LICENSE FEE TRANSMITTAL

1. APPLICATION ATTACHED  
APPLICANT/LICENSEE: MILWAUKEE COUNTY MEDICAL COMPLEX  
RECEIVED DATE: 901010  
DOCKET NO: 3008444  
CONTROL NO.: 390311  
LICENSE NO.: 48-04193-01  
ACTION TYPE: AMENDMENT

We have reviewed your letter dated October 1, 1990, requesting an amendment to License Number 48-04193-01 and find that we will need additional information as follows:

Low Dose Rate Remote Afterloading System  
At MCMC and FMLH

Figure 1

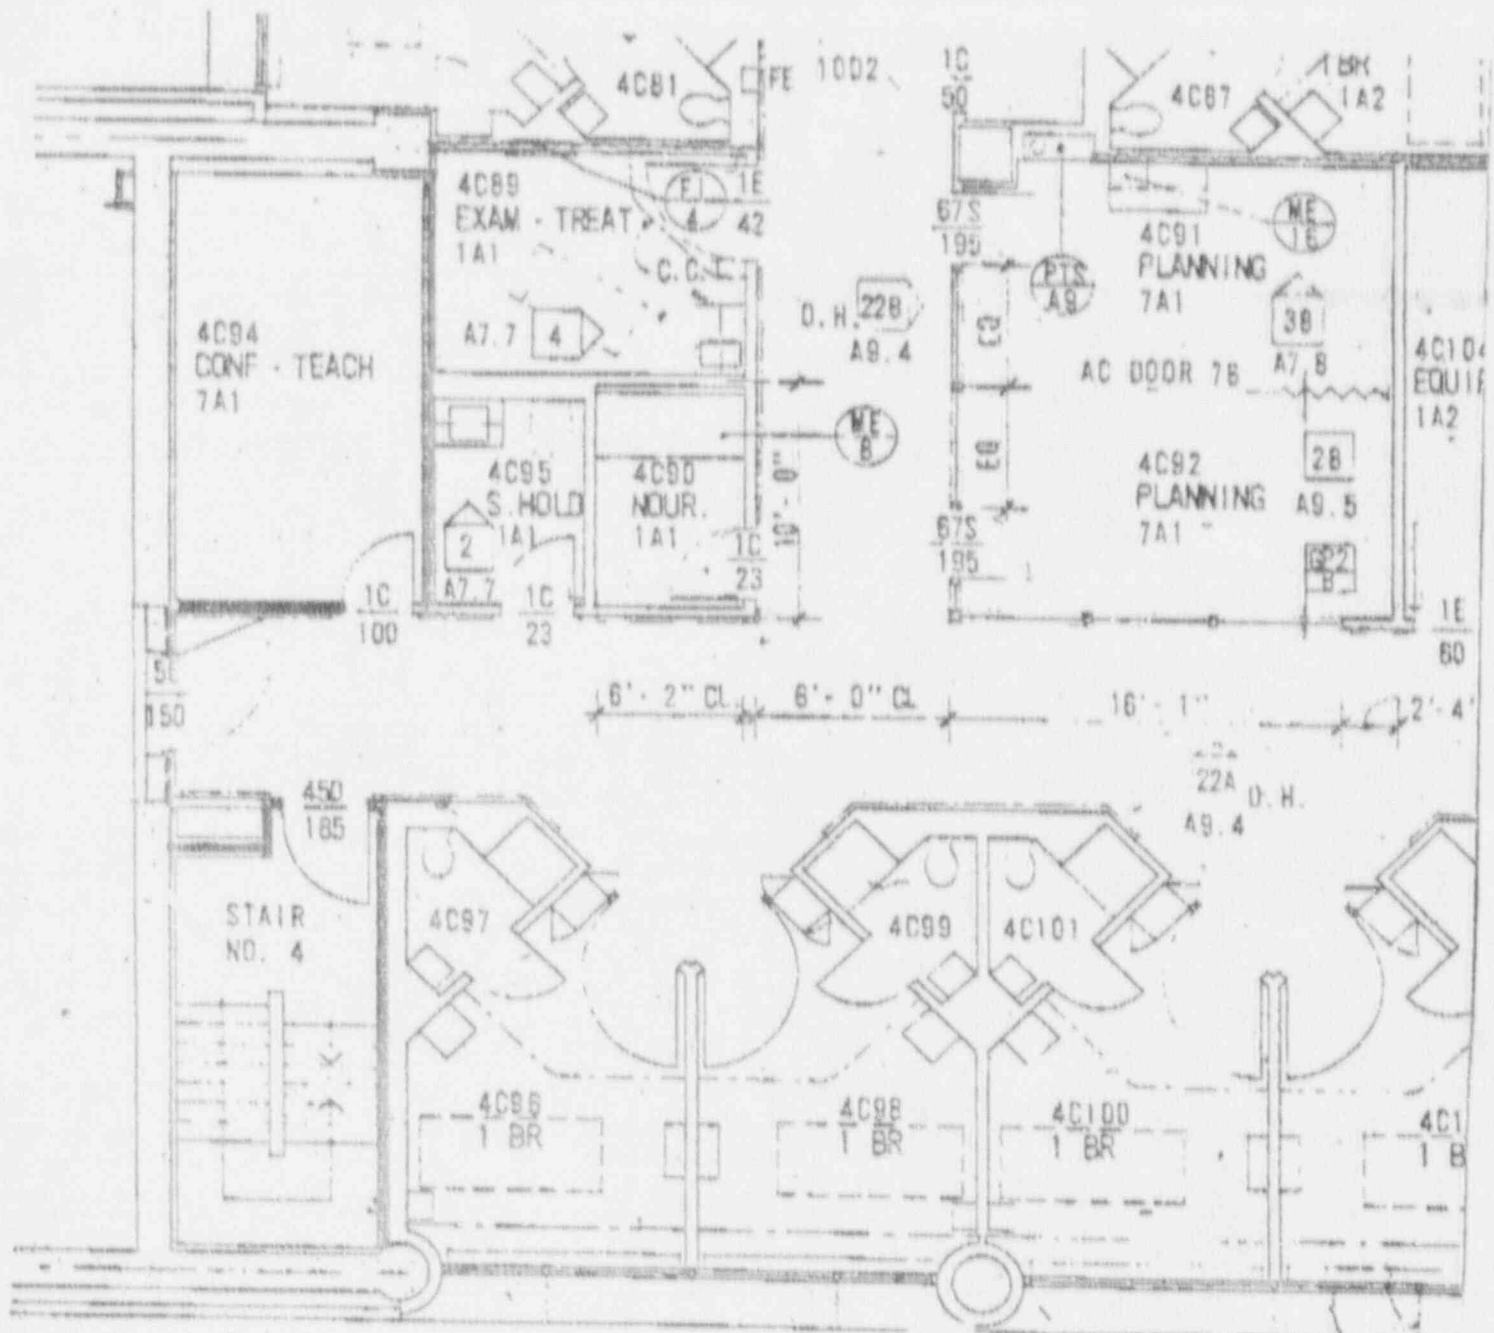
- a. Submit detailed calculations of maximum radiation levels that will exist in each area (restricted and unrestricted) adjacent to and above the room that houses the afterloader device. The calculations should include the following:

- (1) Provide calculations for each area adjacent to the afterloader device room with the most adverse source or orientations and source combinations considered. The calculations must demonstrate that your unrestricted areas adjacent to the treatment room will have radiation levels less than 2 milliroentgen (mr) in any 1 hour and less than or equal to 100 mr in any 7 days (reference 10 CFR 20.105[b][1] and [2]).

- (2) Specify all parameters used in your calculations. These parameters include such factors as distance to area of concern, type and thickness of material(s) used in barrier, and transmission factor of barrier. (Calculations must be provided for "worst case" situations.)

- c. You may designate and maintain your areas as restricted. It appears from your application, Section V.D.2., that you will have areas that will exceed the limits in Part 20.105(b) for unrestricted areas and therefore must be considered restricted (i.e., room 4C98, Hallway, Intestinal spaces, and stairwell). Please submit a more detailed description for each restricted area. The description must include:

- A. Attached is a floor plan of the room 4C96 and adjacent areas (Fig. 1). The room above 5C96 and below 3C96 are of identical layout. The distance from functional floor to functional floor is 18 feet (4.6 m) and the floors are composed of 6" of concrete. There is an interstitial space containing heating and cooling ducts and other utilities located between the functional floor. This space is occupied only during inspections and maintenance work. The distance between the functional floor and the floor of the interstitial walk platform is 10 feet (3 m). This walk platform is concrete 2.5" thick. (See attached diagrammatic section (Fig. 2) of interior partition and ceiling)

- South wall: No shielding required, outside area is above grade.
- East wall: Gypsum wall board, 1 1/4" total thickness on metal studs and lead shielding 1/4" (6.3 mm) to a height of 7 feet (2.1 m). Adjacent area is a patient room and is unrestricted.
- North wall: Lead shield, 1/4" (6.3 mm) to a height of 7 feet (2.1 m). Adjacent area is hospital hallway and is unrestricted.
- West wall: Gypsum wall board, 2 1/2" total thickness on metal studs and lead shielding 1/4" (6.3 mm) to a height of 4.5 feet (1.37 m). Adjacent area is emergency stairwell and is unrestricted.
- Floor: 6" concrete in floor plus 2 1/2" concrete in interstitial walk platform, adjacent area below is a patient room, distance between floors is 18 feet.
- Ceiling: Same as floor.

Room 3C96 and 5C96	: 18 feet (5.5 m)
Fourth floor interstitial space:	10 feet (3.0 m)
Third floor interstitial space :	8 feet (2.4 m)
Room 4C98	: 10 feet (3.0 m)
Hallway	: 12 feet (3.7 m)
Stairwell	: 6 feet (1.8 m)

- a. Room 4C98, distance, 12 feet (3.7 m)  
Access to this room will be restricted. No patient will be housed in this room while the implant is in progress.

- b. Hallway  
An ISO exposure line representing 2 mR/hr will be marked on the floor of the hallway and signs will be placed restricting access to the area behind this line to only radiation workers. Portable bedside shields (2 available) will be used to minimize the area of the hallways so restricted.

- c. Interstitial Spaces (above and below room 4C96)  
These spaces are normally locked and access is limited to engineering personnel. When exposure rate exceeds limits in Section 20.105(b), engineering personnel will only be allowed access to these areas when accompanied by a member of the Radiation Safety staff. Engineering will be notified of each implant for which this restriction applies.

Because of its location, this stairwell is infrequently used and occupancy is essentially nil. In the event exposure levels exceed limits, signs will be placed in the stairwell on the fifth floor and third floors stating that the area between the fifth and third floor is a restricted area, and directing anyone to exit the stairwell on the fifth or third floor except in case of an emergency. It is unlikely even in the event an individual ignores the warning signs that the individual will be exposed to a significant fraction of the recommended maximum annual dose of 0.5 rem for a member of the general public because of the limited time it would take to go between floors (estimated time less than 15 seconds).
